**Application No.: PL8704**

Description :	
Address :	
Record Type :	PLAT

# PRELIMINARY PLAT OF SOUTHSIDE STORAGE TRACT BLOCK 1, LOT 1

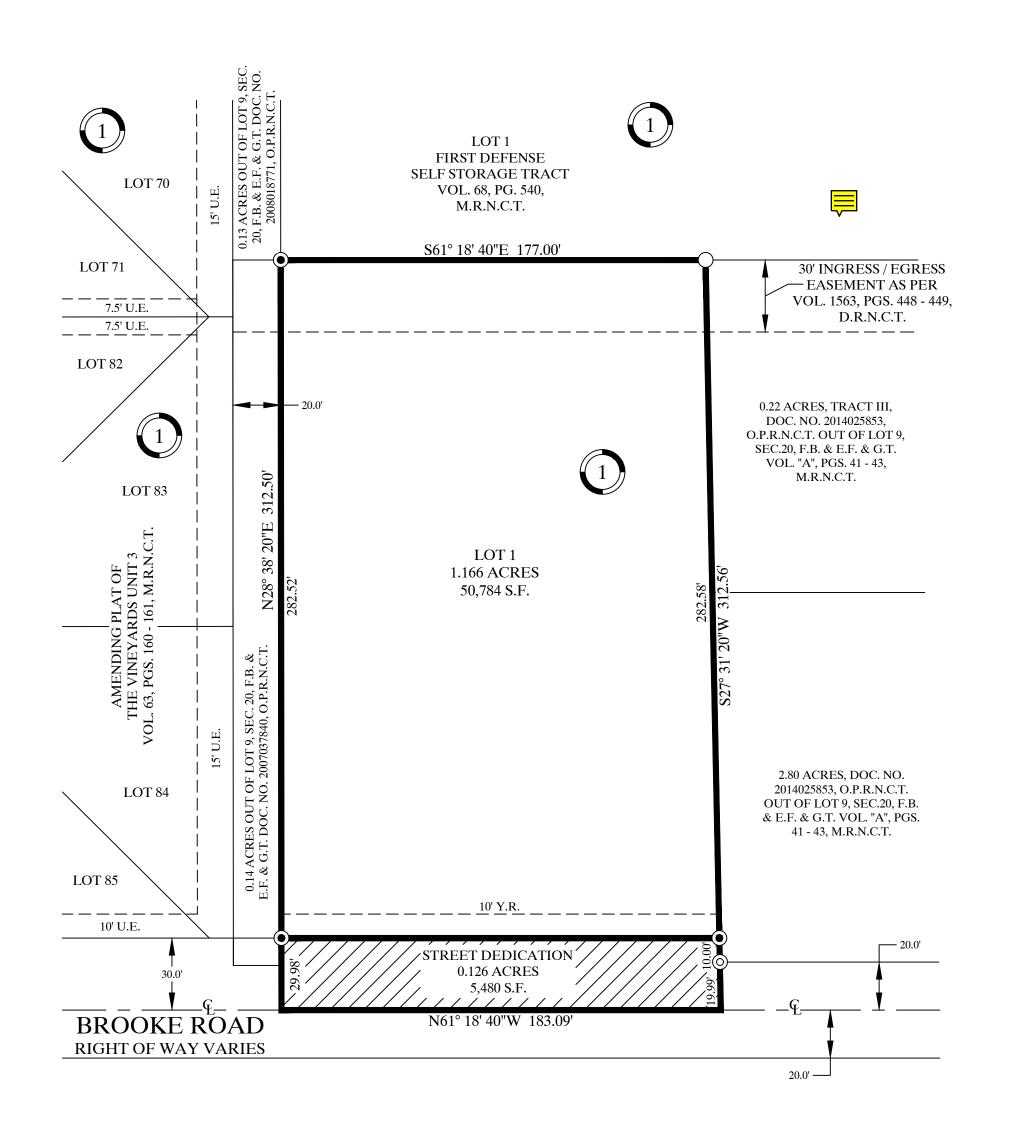
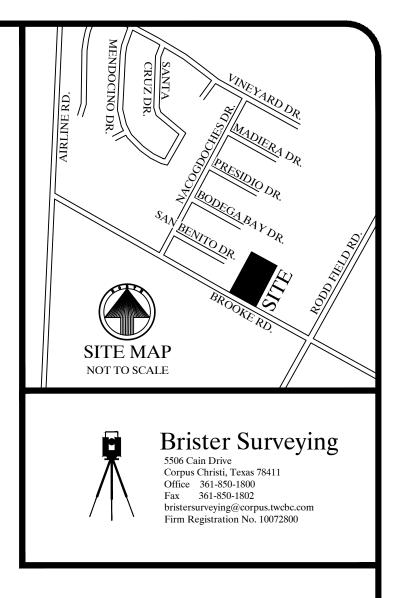
Comment ID	Page Reference	Annotation Type	Author : Department	Status	Review Comments	Applicant Response Comments
3	P001	Note	Mina Trinidad : DS	Closed		
4	P001	Note	Mina Trinidad : DS	Closed	(Informational) CCRTA: This plat is not located along existing or foreseeable planned CCRTA service routes.	
9	P001	Note	Mina Trinidad : DS	Closed	(Informational) Traffic/ROW: Proposed driveway access to a public City Street shall conform to access management standards outlined in Article 7 of the UDC (UDC 7.1.7)	
10	P001	Note	Mina Trinidad : DS	Closed	(Informational) Traffic/ROW: The PW-Traffic Department(Right-of-Way Division) is responsible for reviewing and permitting new construction and repairs/modifications to driveways, sidewalks, and curb and gutter. The review and approval of the permit must be approved prior to the issuance of the building permit (issued by DSD). (Refer to Municode Chapter 49-30 for permit requirements.)

11	P001	Note	Mina Trinidad : DS	Closed	(Informational) Traffic/ROW: Pavement markings shall be installed within the scope of the subdivision in accordance to specifications of, and subject to, latest version of the "Texas Manual on Uniform Traffic Control Devices (TMUTCD), public improvement plan reviews and inspections, by the City. Reference: Texas MUTCD and UDC Article 8.1.3.A	
12	P001	Note	Mina Trinidad : DS	Closed	(Informational) Traffic/ROW: Any street excavation, utility cut, or utility tap requires a permit issued by the Traffic Department (Right-of-Way Division). Restoration requirements are subject to the street Pavement Condition Index (PCI) and street age. New streets (Any street 0-6 years and / or PCI ≥ 80) will require restoration of 25-ft beyond the outermost edge of the excavation and up to curb to curb repair. Older streets (Any street > 6 years or PCI < 80) will require restoration of 10-ft beyond the outermost edge of the excavation and up to full lane (Refer to Municode Section 49-47-1).

13	P001	Note	Mina Trinidad : DS	Closed	(Informational) Traffic/ROW: Sidewalks required on both sides of local street as per IDM Chapter 6 - Street Design Requirements. Table 6.2.2 Street Right-of-Way Dimension Standards	
14	P001	Note	Mina Trinidad : DS	Closed	(Informational) Parks and Recreation: No fees due as no residential building is being built. Plat is for the construction of a restroom facility/asset.	
16	P001	Note	Mina Trinidad : DS	Closed	Add "D.R.N.C.T" to legend.

Comment ID	Page Reference	Annotation Type	Author : Department	Status	Review Comments	Applicant Response Comments
17	P001	Note	Mina Trinidad : DS	Closed	Give more detail on the creation of the ingress/egress easement. Or, upload associated documentation.	
5	Utility Plan	Note	Mina Trinidad : DS	Closed	Fire: Fire needs additional information. What is the purpose of building a restroom in an existing storage facility. Are there plans to allow a residential living area? Where is the main entrance. Signage indicates that the main entrance is at 3207 Rodd Field Rd. The address of 7106 Brooke is a rear gate and not in our Computer Aided Dispatch as a viable address. You may call the Fire Marshal's Office to have an inspector go out to the area to explain what is the purpose of building a single restroom at this facility. Capt. Mark D. Lewis	
18	Utility Plan	Note	Mina Trinidad : DS	Closed	Fire Comments 1-4:  1. Note: All code reference is based on currently adopted International Fire Code (IFC) 2021 and Corpus Christi Water Distribution Standards.  2. Commercial Development shall have a fire flow of 1,500 GPM with 20 psi residual.  Fire hydrant every 300 feet and operational.  3. 507.5.1 (amendment) Where Required: All premises, other than one-family detached dwellings, where buildings or portions of buildings are located more than 150 feet from a fire hydrant shall be provided with approved on-site hydrants and water mains capable of supplying the fire flow require by the fire official. The minimum arrangement being so as to have a hydrant available for distribution of hose to any portion of building on the premises at distances not exceeding 300 feet.  4. Commercial development of the property will require further Development Services review.
